Planned Residential Development Staff Report and Recommendation

FILE NUMBER: 311-20-000010-PLNG

FILE NAME: Kingwood Commons Planned Residential Development

RECOMMENDATION: Staff recommends approval with conditions

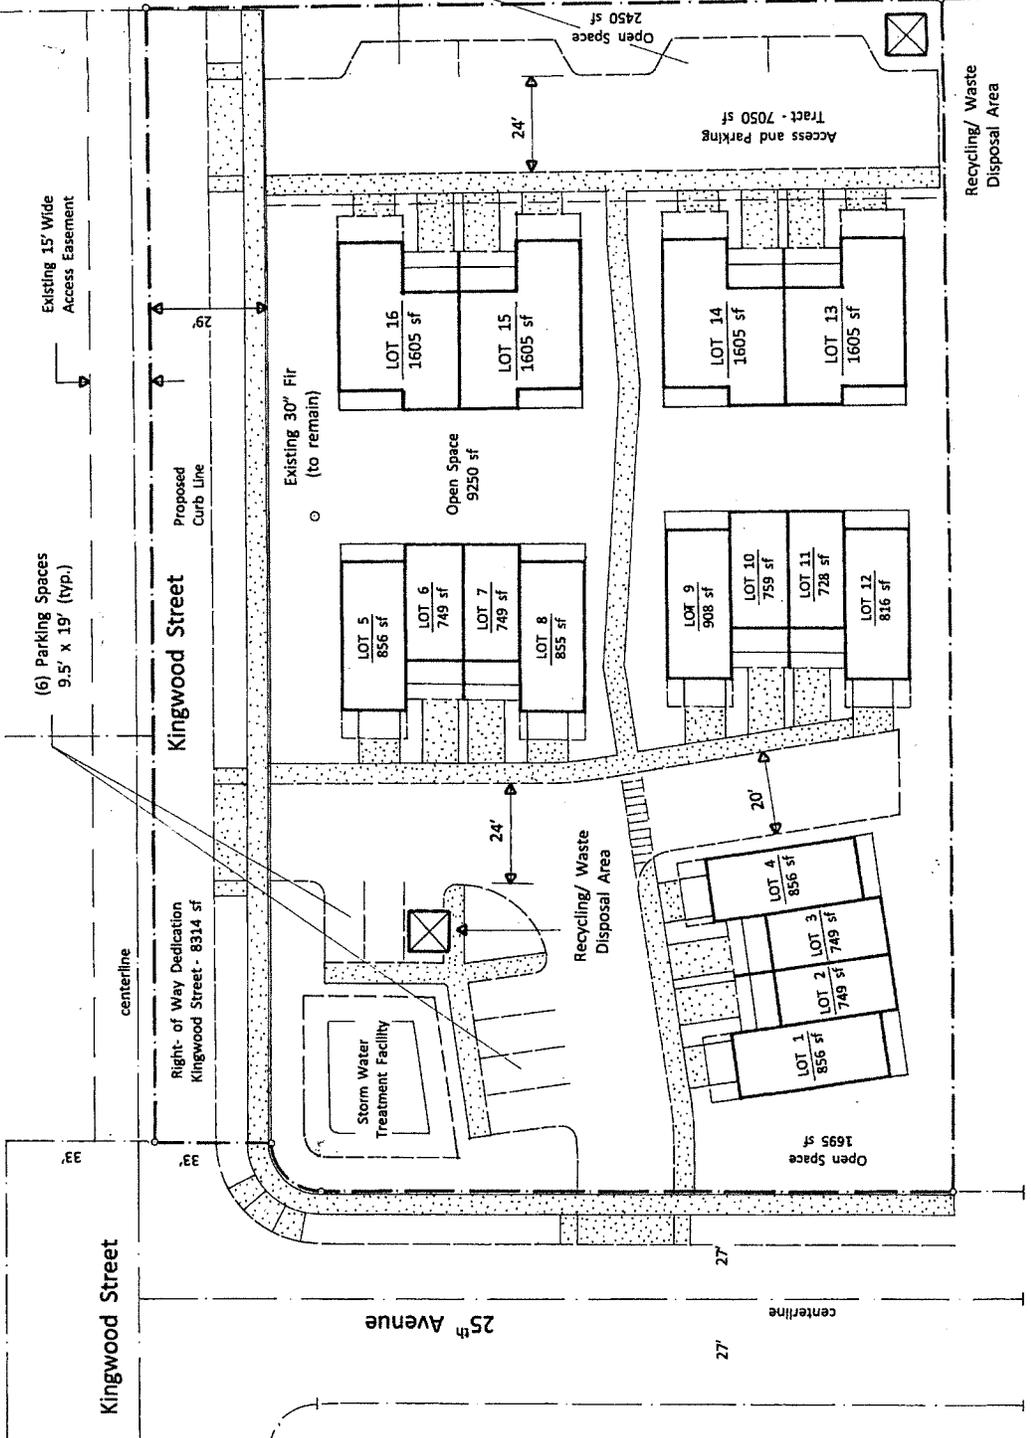
DC §17.8.610(G)(2) requires that Local street intersections be at least 125 feet apart. While Kingwood Street could be designed to comply with this standard, the larger question is whether this Local street connection is necessary to provide adequate neighborhood circulation.

Extending all four of the planned streets near the project site (25th Avenue, Kingwood and Laurel streets, and the 23rd/24th Avenue extension) would create a small block that would measure only about 120 feet by 330 feet, making it one of the smallest blocks in the city. In addition to the expense this applicant would incur, additional right-of-way and construction expense would be imposed on 2355 Kingwood Street that would render its redevelopment potential less likely, given the cost of improvements versus the unit yield.

Because two Collector streets would be located nearby, staff has concluded that the construction of Kingwood Street is unnecessary for access, circulation, or utility connectivity. Instead, staff is recommending a **condition** that Kingwood Street be constructed as a cul-de-sac (perhaps a hammerhead) that would provide access only to the project site and 2355 Kingwood Street, which at present has no deeded access to a public street. Public utility easements may also be required for any utility extensions necessary to serve the project site that would have otherwise been located in a street right-of-way.

1. Install a play structure within a fenced enclosure. At least two benches shall be located nearby.
2. Kingwood Street shall terminate in a cul-de-sac in the vicinity of the north property line of 2355 Kingwood Street. Pursuant to DC §17.8.610(K)(1) *Cul-de-sacs*, "Use of turnaround configurations other than circular (*e.g. a hammerhead*) shall be approved by the City Engineer."
3. Pursuant to DC §17.8.615 *Easements*, easements shall be provided for all public utilities not located in a street right-of-way.

Subdivision Plan

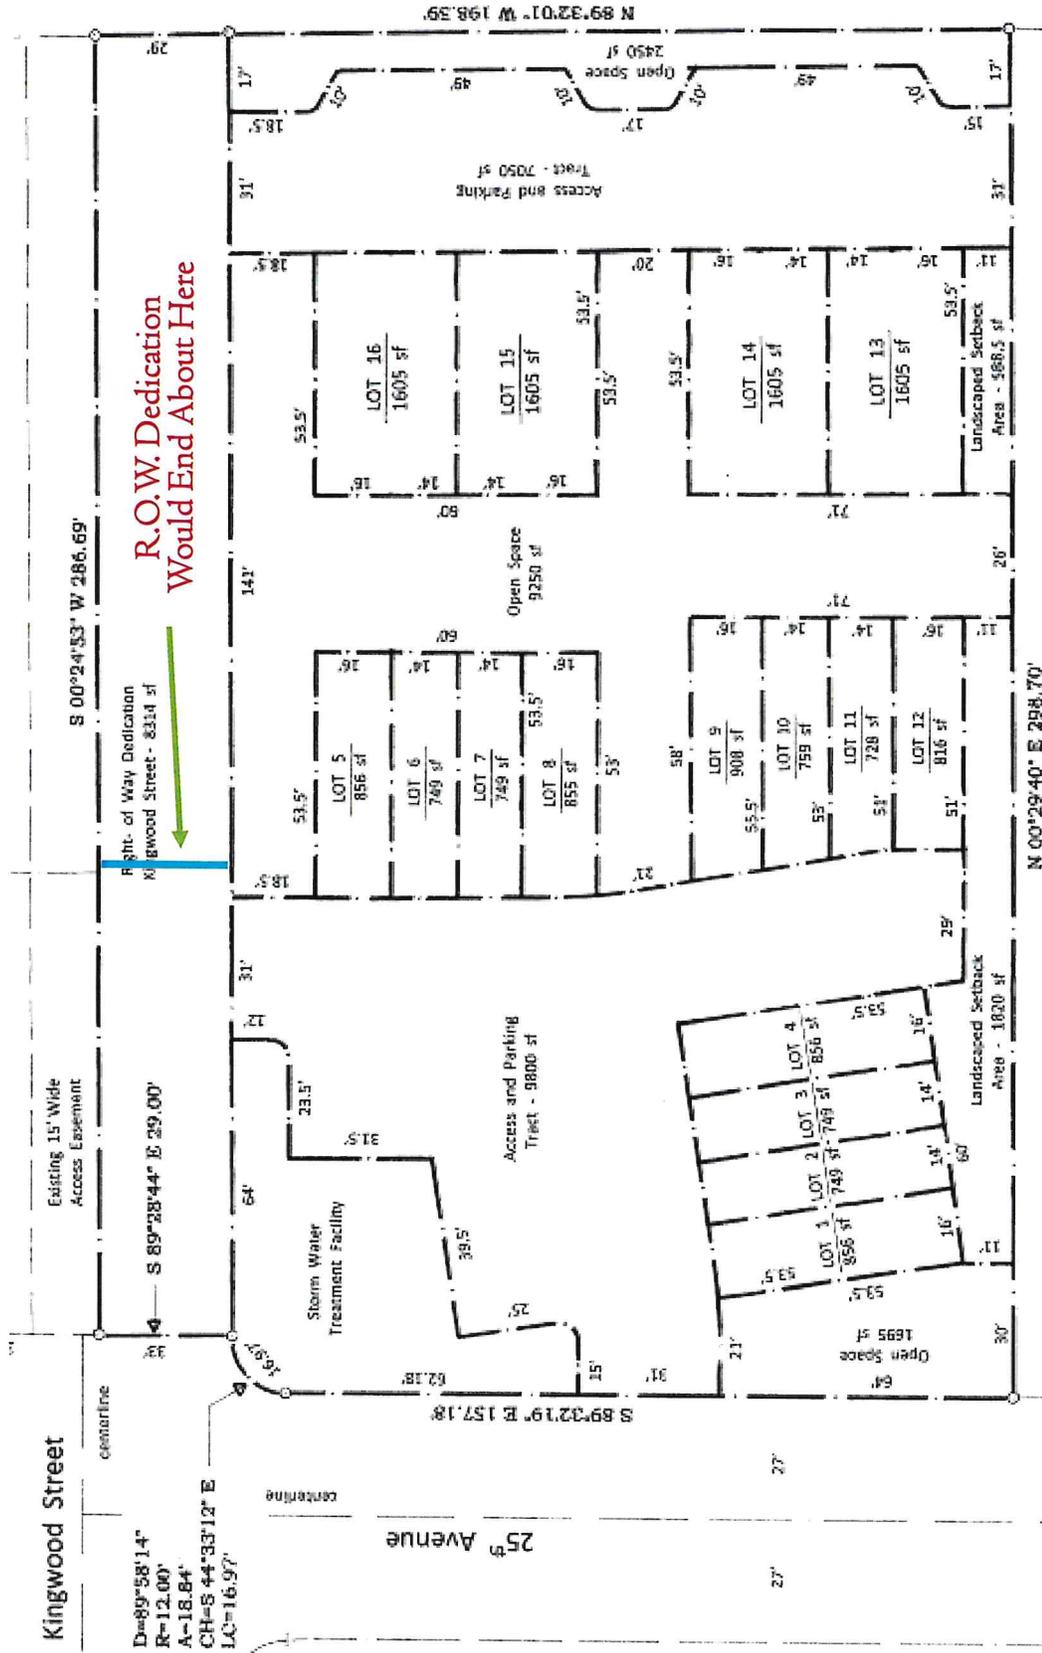
Due to the lack of nearby recreational facilities, especially for those future residents with small children, staff is recommending a **condition** to include a tot lot and play structure on the site. This recommendation would be consistent with other planned developments located at distance from any City park, including Casey Meadows, Casey West and Silverstone. Older children and adults could traverse the distance to Bard Park and make use of those recreational facilities.

Finding: No recreational facilities are proposed, and no City park is located within a reasonable walking distance, especially for families with small children. For that reason, a tot lot and play structure will be required, as a condition of approval.

1. The applicant is bound to the project description and all representations made by the applicant during the application and decision-making proceeding.
2. The applicant shall comply with all applicable City building and development standards, including all dimensional standards and public works specifications.
3. Kingwood Street shall be designed as a cul-de-sac, terminating in the vicinity 2355 Kingwood Street, as approved by the Engineering Department.
4. Install a play structure within a fenced enclosure. At least two benches shall be located nearby.
